Pentium® II Processor Specification Update

Release Date: August 1997

Order Number: 243337-004

The Pentium® II processor may contain design defects or errors known as errata which may cause the product to deviate from published specifications. Current characterized errata are documented in this Specification Update.

NOTES FOR FIGURE 1 THROUGH FIGURE 10

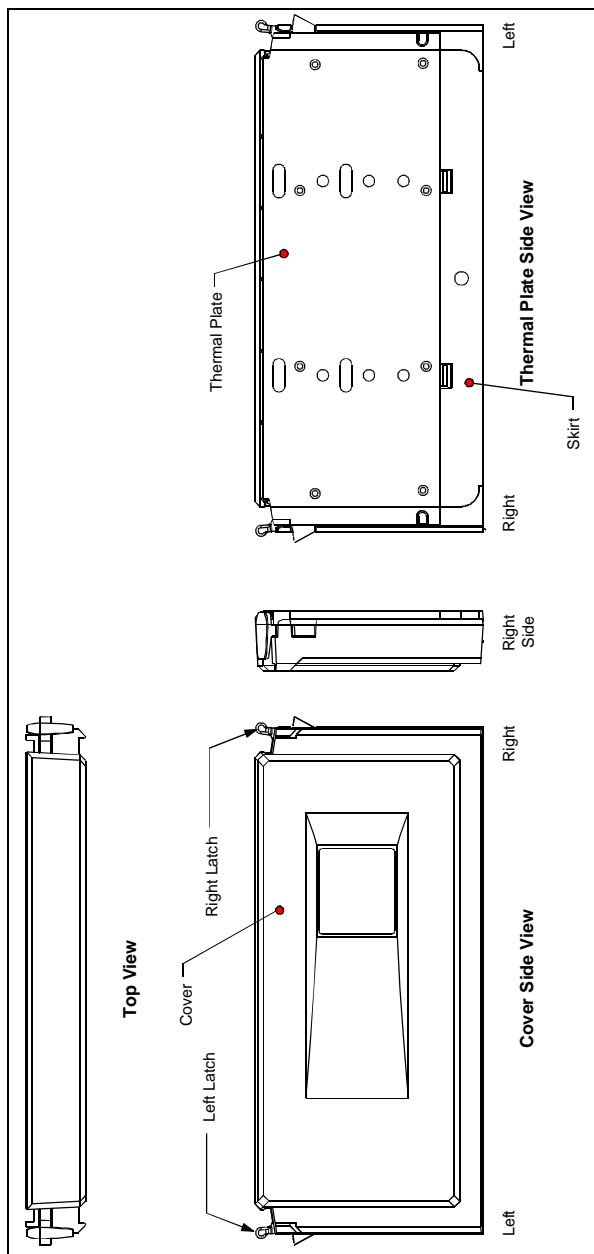
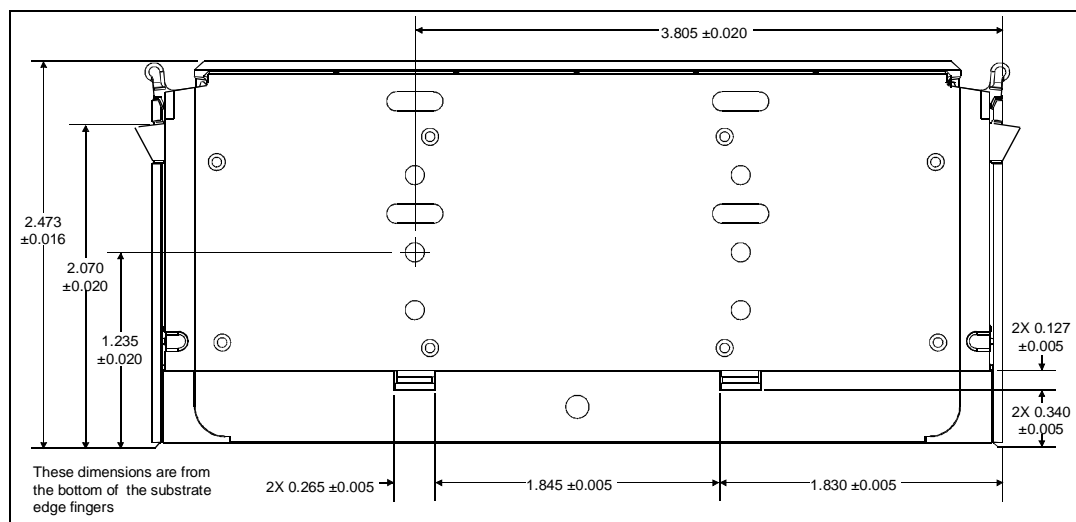
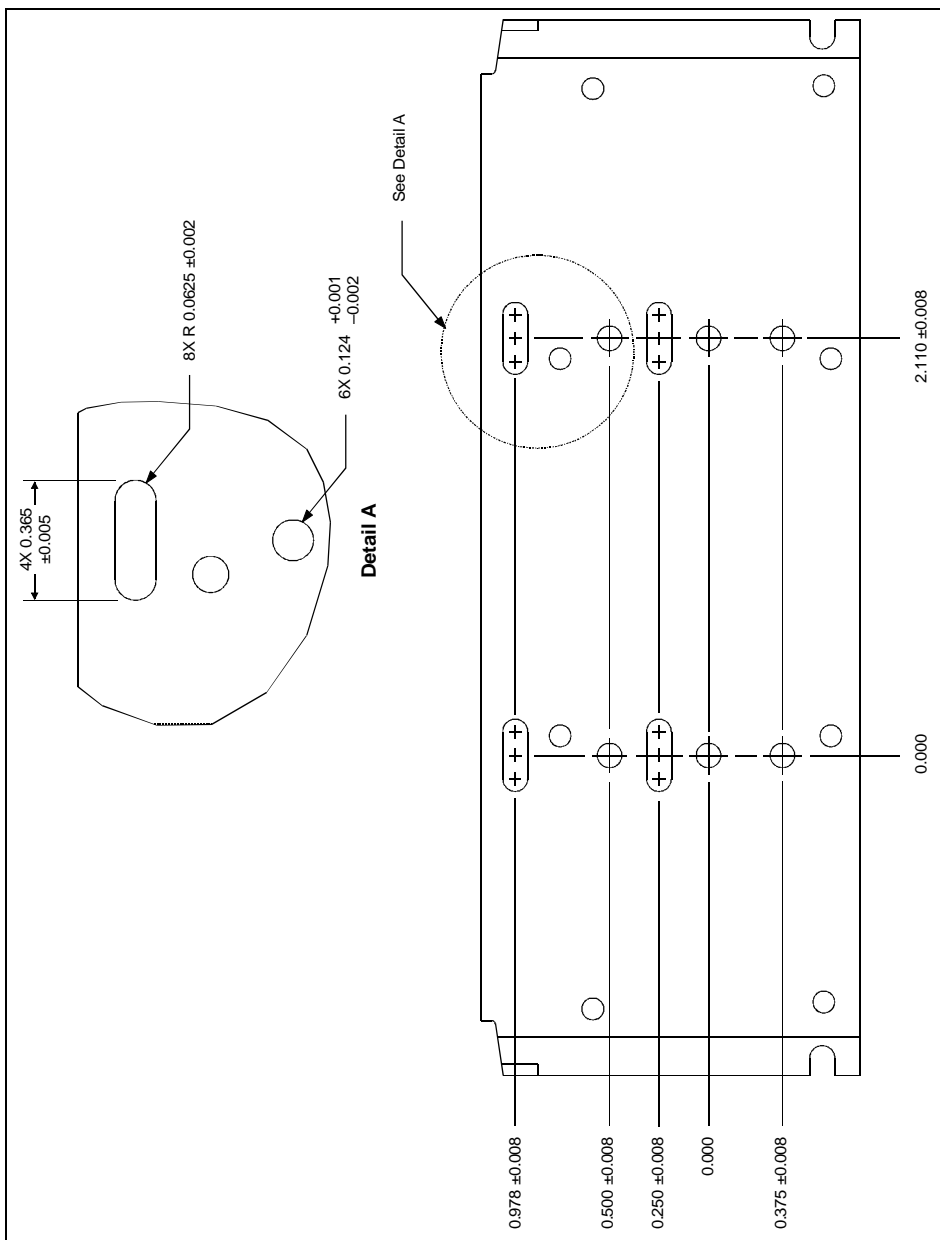
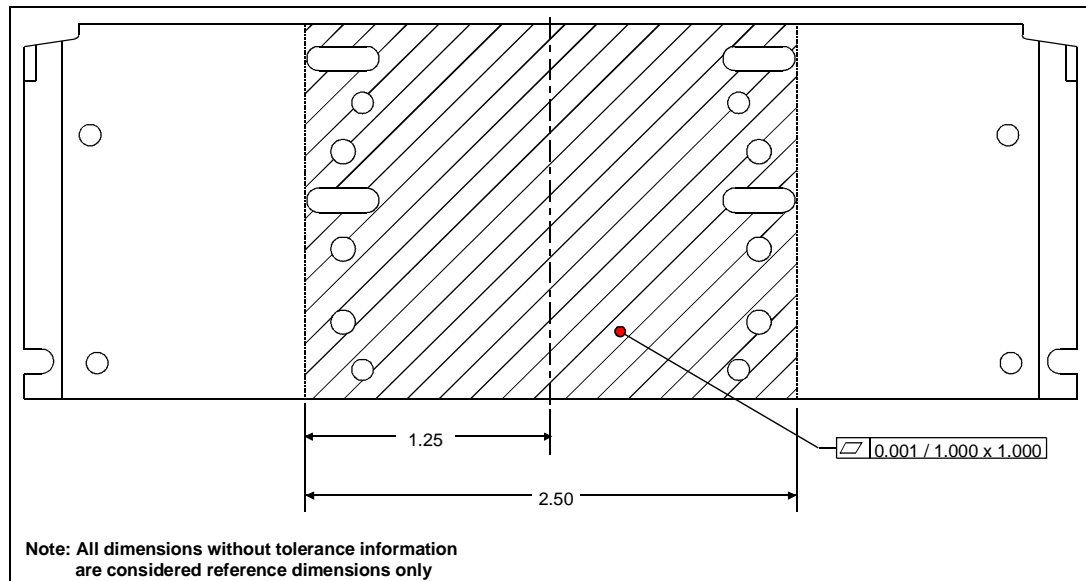
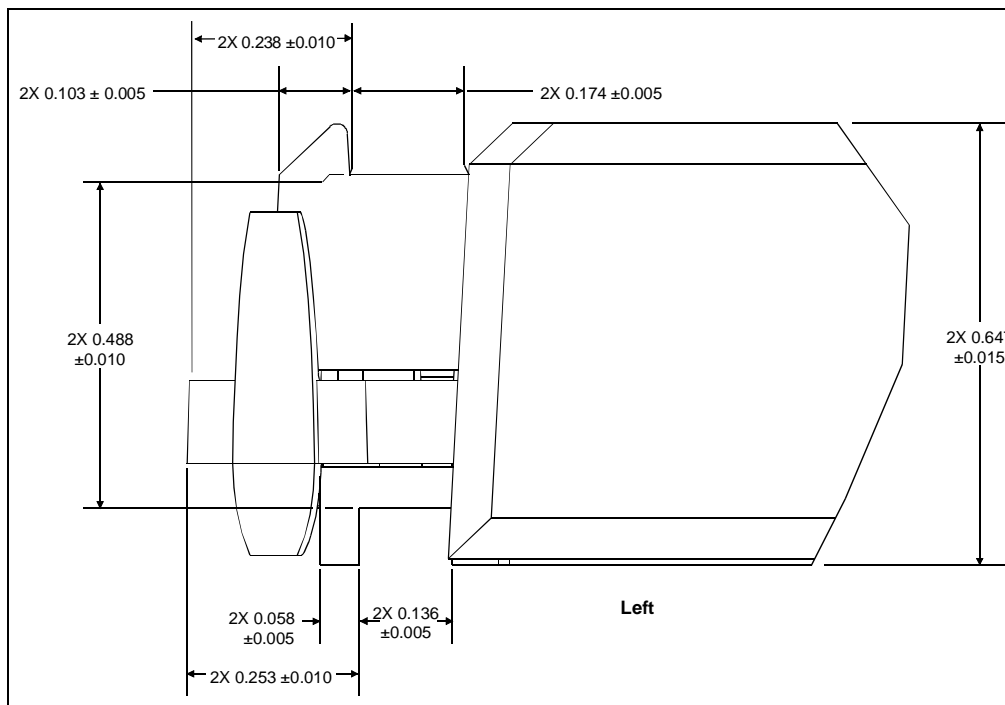
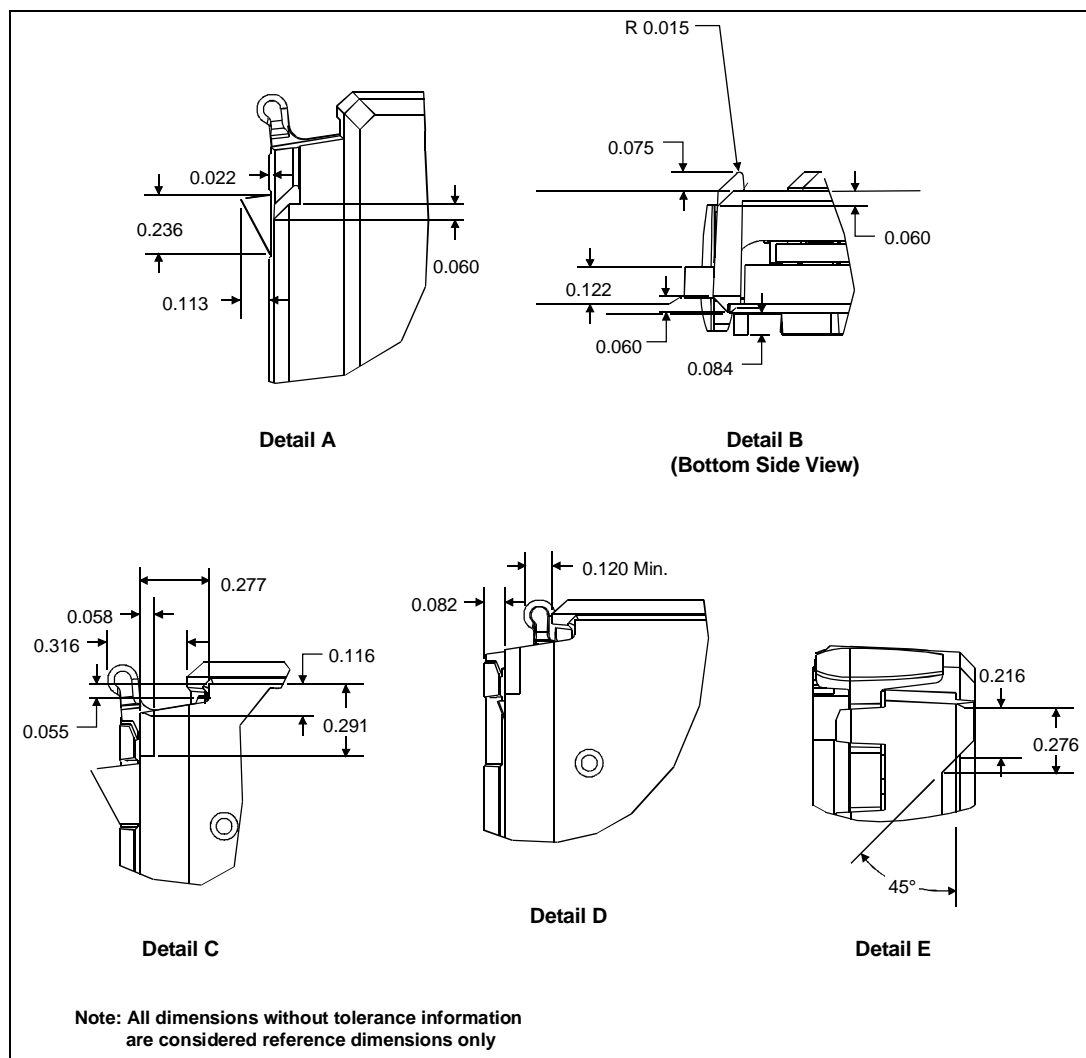
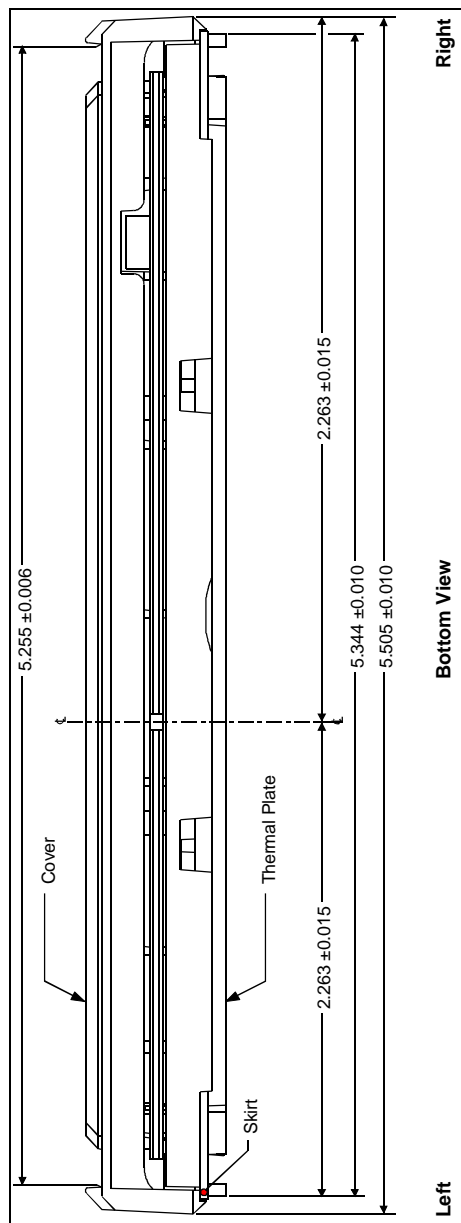
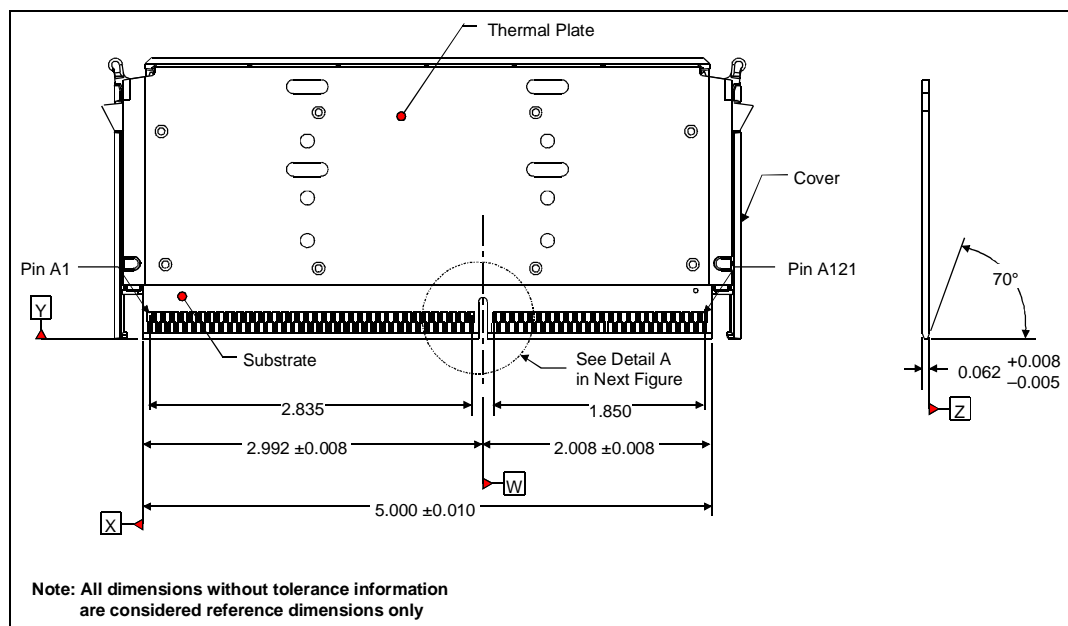
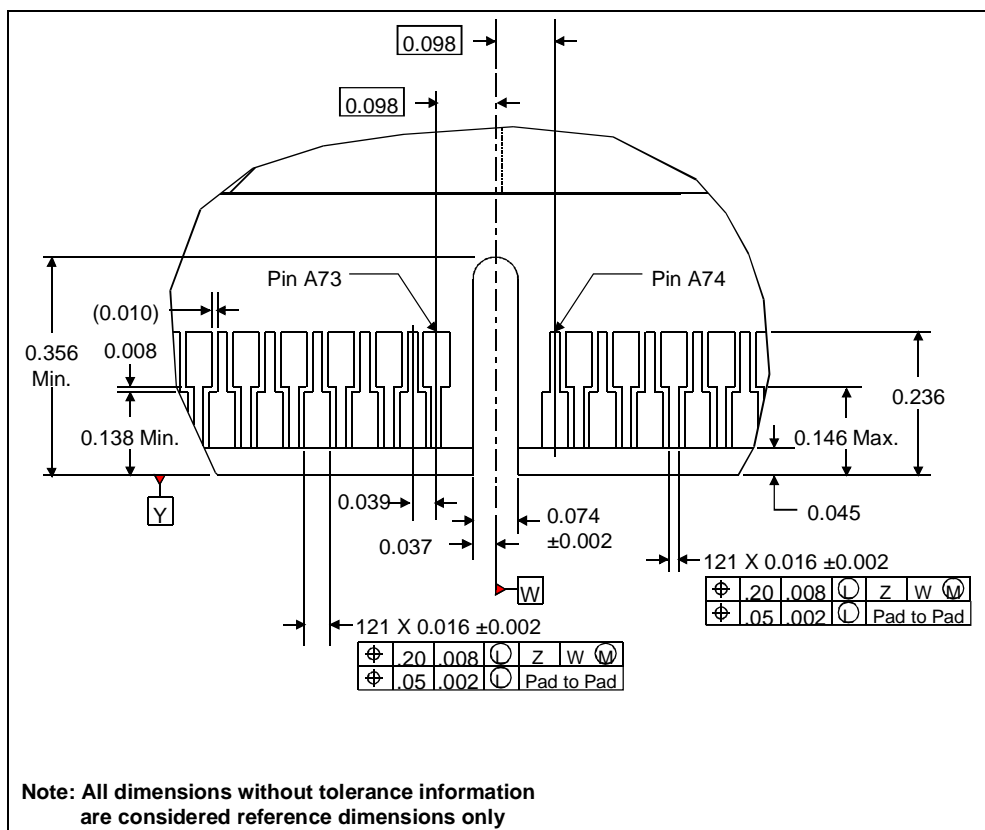
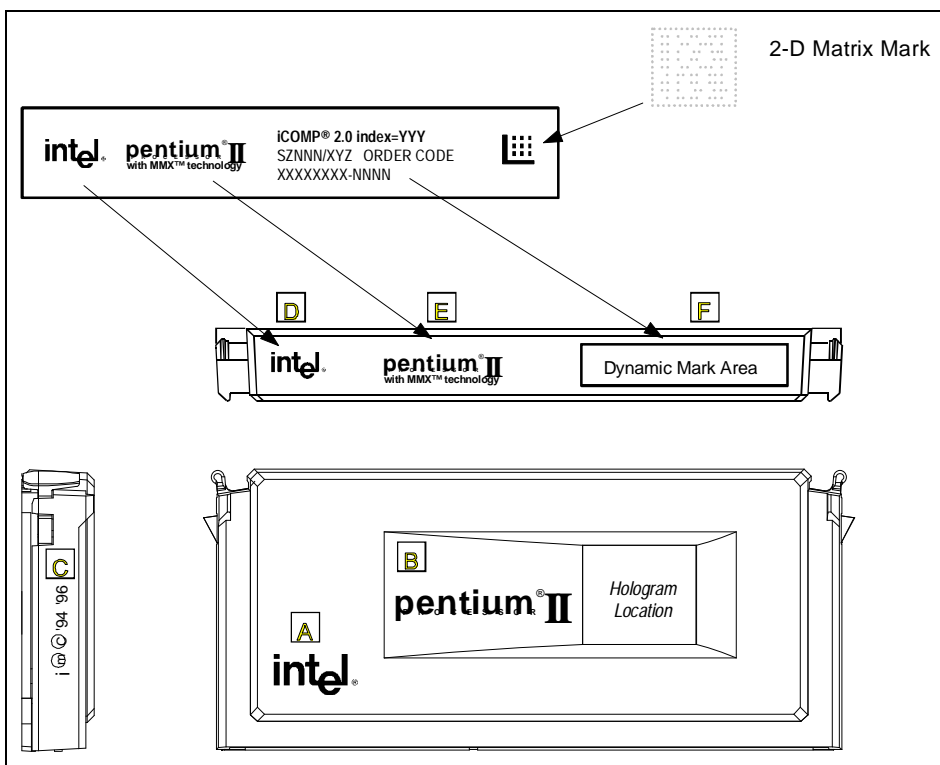
The S.E.C. cartridge mechanical specifications provided in the *Pentium® II Processor at 233 MHz, 266 MHz and 300 MHz* datasheet contained incorrect tolerance information for some dimensions. Also, some of the information provided in the figures was duplicitous and not required to accurately use and design for the S.E.C. cartridge package. The revised figures provided in this section are meant to replace Figures 29 through 42, Table 23 and the accompanying notes found on page 44.

Figure 11. Heatsink Attachment Mechanism Design Space

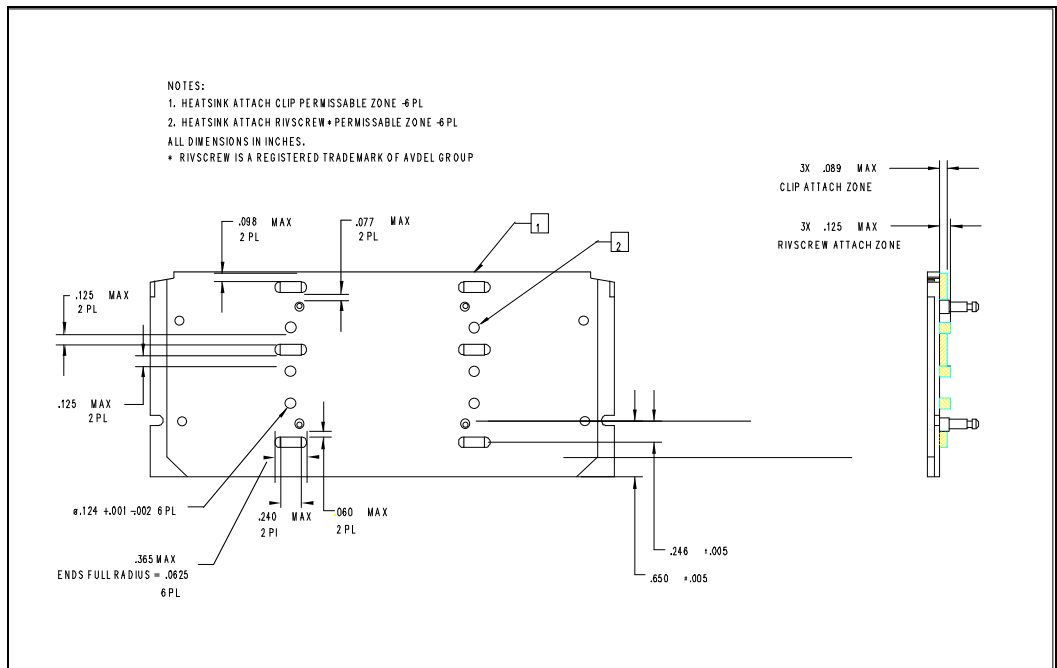
A change to the attach mechanism specification is provided below. The original specification for clearance of heatsink attach solutions is provided in Section 4.3 (and Figure 23 and Figure 24) in the *Pentium® II Processor at 233 MHz, 266 MHz and 300 MHz* datasheet. Figure 11 shows the revised maximum specifications for heatsink clip and Rivscrew® attach mechanism designs. All heatsink clip and Rivscrew attachment solutions must remain within the respective maximum “permissible” zone as detailed in Figure 11.

The thermal plate shown in Figure 11 is used to portray the heatsink attach mechanism design space for the future Slot 1 processors. However, the maximum “permissible” design space is also valid for both the current Pentium II and future Slot 1 processors.

Please review the proposed specifications to guarantee compatibility with existing Pentium® II and future Slot 1 processor heatsink attachment solutions. Note that the required heatsink attachment solution space should not exceed the maximum proposed design space while installed or during the installation and removal procedure.
